WAITOMOKIA ESTATE PLAN CHANGE – TRANSPORT CLAUSE 23 RESPONSES

Flow Transportation Specialists Limited (Flow) has prepared this letter responding to the transport-related Clause 23 Requests for Further Information (RFI) received from Auckland Council (Council) on the proposed Waitomokia Estate Plan Change in Mangere, Auckland (the Site).

REV	AMENDMENT	DATE OF ISSUE	DESIGN: GV	DRAWN: GV
A	First Issue	20/12/2023	CHECKED: TC	DATE: 12/20/2023
SCALE:			0 20m	
			1:500 @ A3

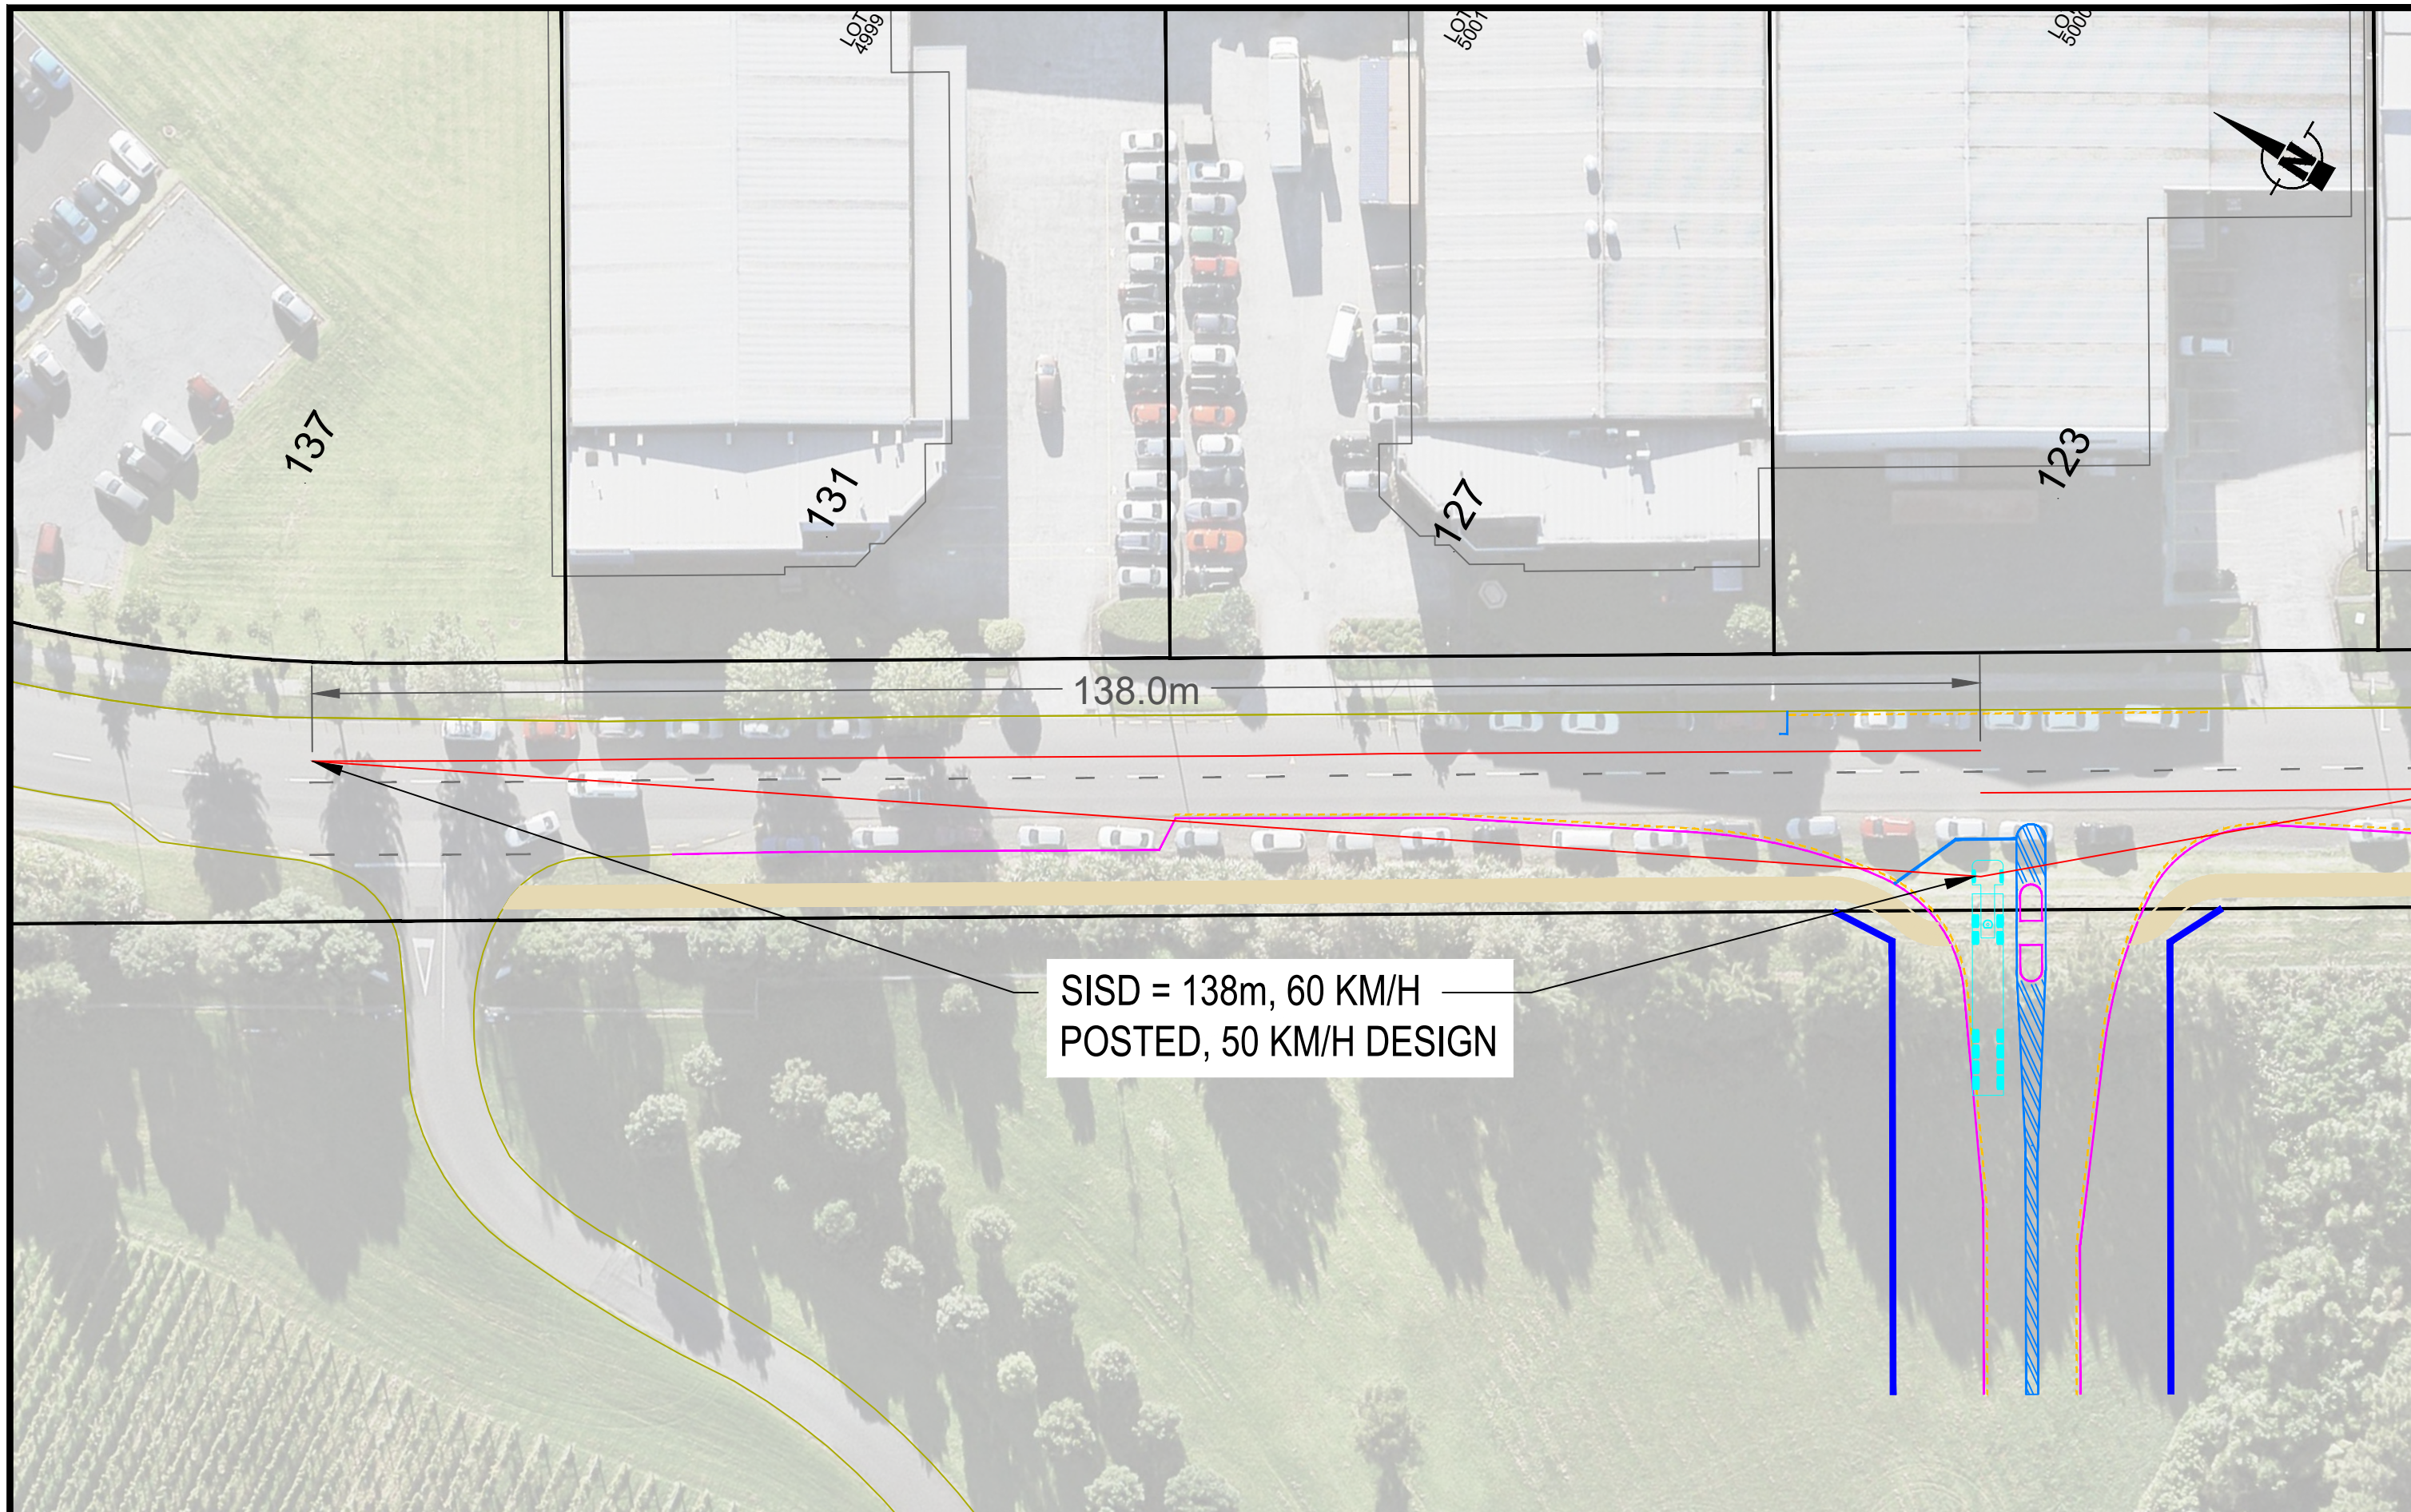
- *anticipated urban transport functions, including access for freight, public transport and pedestrians and active mode users (including provision of pedestrian and cycle facilities to the Oruarangi Rd/Ascot Rd roundabout intersection along the proposed urban road frontage), with any potential access for public transport being subject to engagement with Auckland Transport;*

- *key principles to inform it's likely future urban form and cross-section design, based on identified transport functions (e.g. provisions for on-street parking, public transport infrastructure if applicable, provisions for active mode users etc.) and how the proposed precinct provisions will incorporate these principles, particularly in relation to being designed for a low speed environment; and*

- *assessment of key principles for future intersection with Montgomerie Road, including an assessment of visibility, separation from any existing vehicle crossings or intersections, and potential for alternative intersection forms based on outcomes from any updated trip generation assessments provided in response to further information item 7(a)(i) above.*

We have prepared a concept design of the Montgomerie Road access, attached as Appendix C. The concept design identifies the appropriate location for access, pedestrian provision requirements across the access road in the form of a refuge island, like the one at the Pavilion Drive intersection, the extent of kerbs required and where parking restrictions are required to enable the required sight lines at the newly formed intersection. We emphasise that this is a concept design and detailed elements will be confirmed and designed at subsequent resource consent stages. The concept design purely outlines the location that enables sufficient sight lines with an indication of how pedestrian and parking provisions along Montgomerie Road may look.

We consider a stop-controlled T-shaped intersection to be the most appropriate intersection form that will facilitate heavy vehicle movements in and out of the plan change area. The stop-controlled intersection could operate with sufficient capacity as outlined in our ITA, with appropriate sight line provisions in both directions for a design speed of 60km/hr (10 km/hr above the posted speed limit). The provision of kerb and channel on the western side of Montgomerie Road will further contribute to reflecting the urban nature of the road and a calmer traffic environment. Given the industrial nature of the area, vertical traffic calming devices are not recommended.

As outlined in the concept design safe intersection sight distances (SISD) of 138 m to the north and 133 m to the south are achieved along Montgomerie Road, reflecting sufficient SISD for an operating speed of 50 km/hr (design speed of 60 km/hr and consideration of vertical alignment).
